RE: Vesting Tentative Tract Map No. 78277-SL-M1

LETTER OF CORRECTION

LETTER OF MODIFICATION

MODIFICATION OF VESTING TENTATIVE TRACT NO.78277-SL-M1

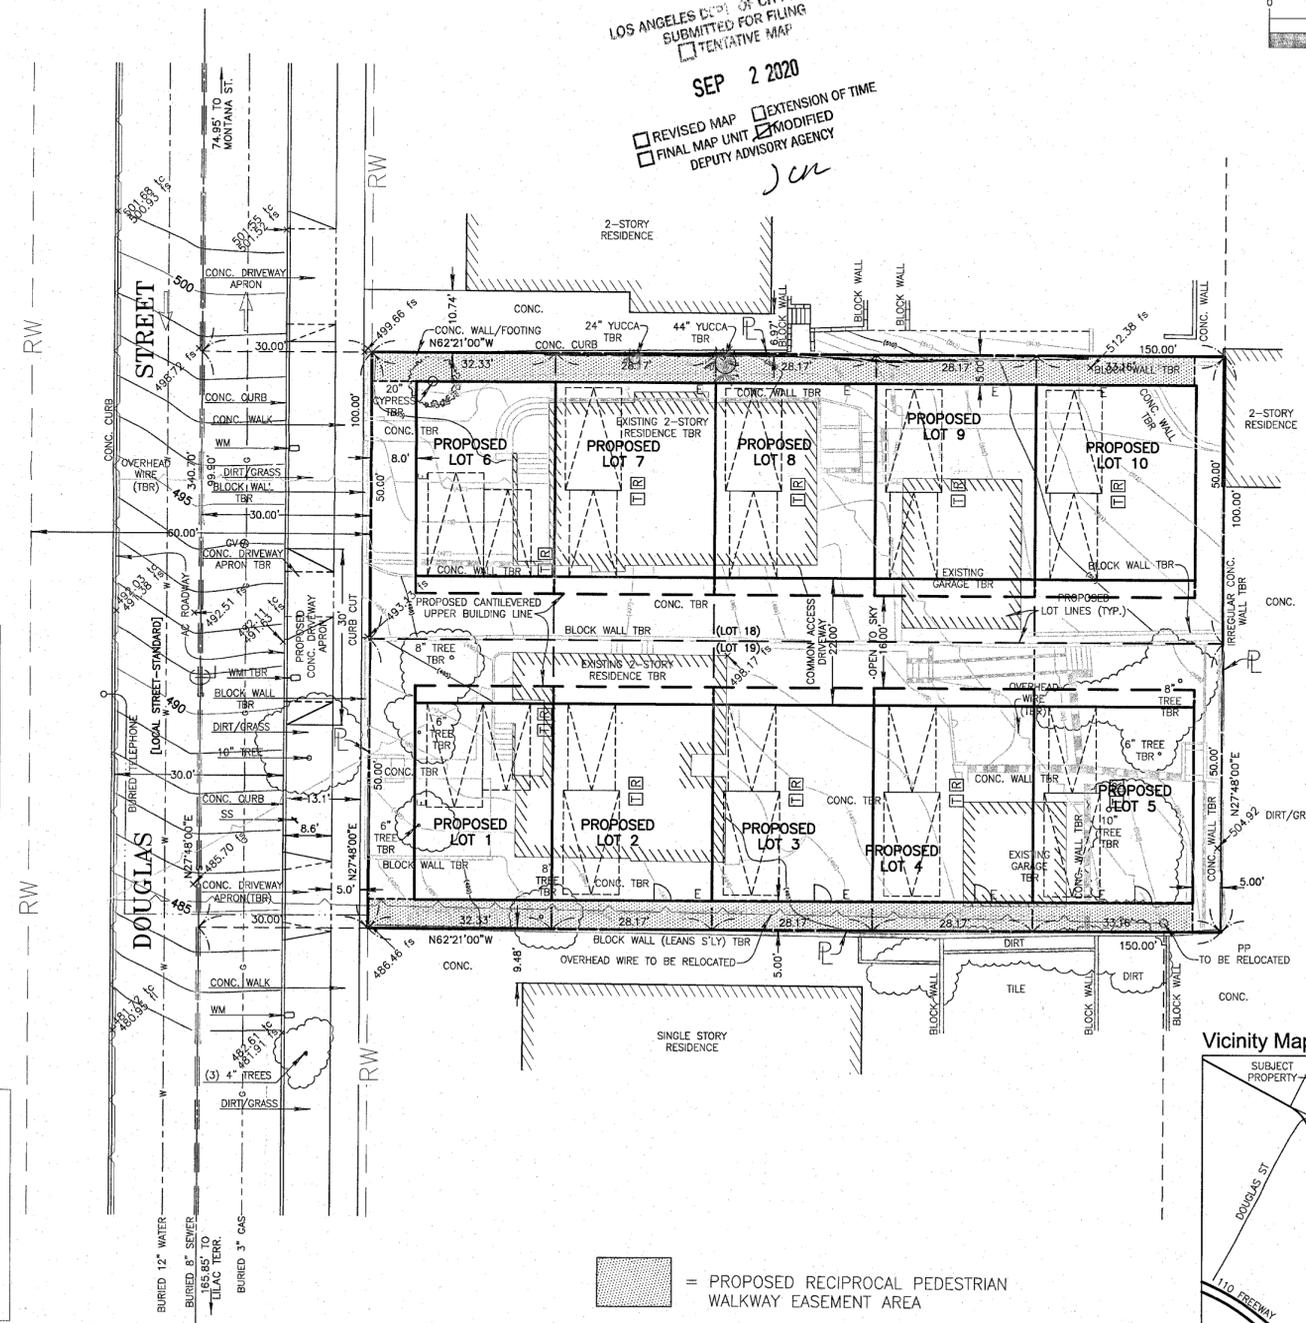
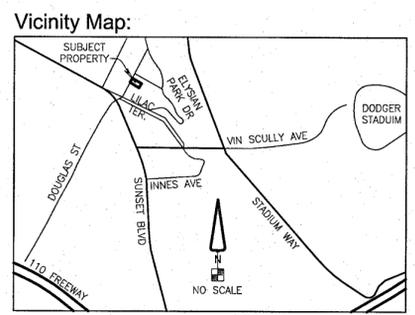
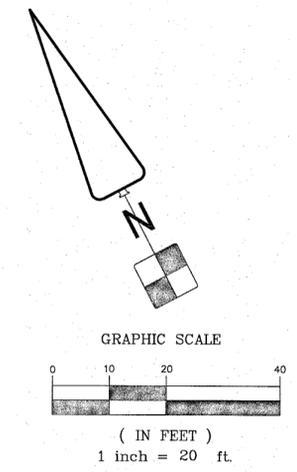
On September 2, 2020, the applicant filed a **Modification** to adjust the property lines and modify the setback dimensions in the setback matrix in Condition No. 17.k. under the Department of City Planning – Site Specific Conditions. The modification is being requested as a result of minor revisions to the site layout for each of the ten (10) small lot homes.

In accordance with the provisions of Sections 17.03 and 17.11 of the Los Angeles Municipal Code, the Advisory Agency considered and hereby approves a Modified Map stamp-dated September 2, 2020, and a **Modification** request to modify the setback matrix in Condition No. 17.k.

The Advisory Agency, therefore, modifies the setback dimensions in the setback matrix in Condition No. 17.k. as delineated by this letter. Additionally, comment letters were received in response to the modification request. The Bureau of Engineering, Building and Safety-Grading, Building and Safety-Zoning, the Fire Department, Department of Water and Power, and the Bureau of Sanitation submitted comments. The Bureau of Engineering, Building and Safety-Grading, and the Bureau of Sanitation did not submit additional conditions or modify their existing conditions for the Modified Map stamp-dated September 2, 2020; however, Building and Safety-

Lot No.	Setbacks			
	<i>Front (W)</i> West	<i>Rear (E)</i> East	<i>Side (N)</i> North	<i>Side (S)</i> South
1	8'-0"	0' <u>0.33'</u> -0"	8'-0"	5'-0"
2	0' <u>0.33'</u> -0"	0' <u>0.33'</u> -0"	8'-0"	5'-0"
3	0' <u>0.33'</u> -0"	0' <u>0.33'</u> -0"	8'-0"	5'-0"
4	0' <u>0.33'</u> -0"	0' <u>0.33'</u> -0"	8'-0"	5'-0"
5	0' <u>0.33'</u> -0"	5'-0"	0' <u>8'</u> -0"	5'-0"
6	0' <u>0.33'</u> -0"	0' <u>0.33'</u> -0"	5'-0"	8'-0"
7	0' <u>8'</u> -0"	0' <u>0.33'</u> -0"	5'-0"	8'-0"
8	0' <u>0.33'</u> -0"	0' <u>0.33'</u> -0"	5'-0"	8'-0"
9	0' <u>0.33'</u> -0"	0' <u>0.33'</u> -0"	5'-0"	8'-0"
10	0' <u>0.33'</u> -0"	5'-0"	5'-0"	0' <u>8'</u> -0"
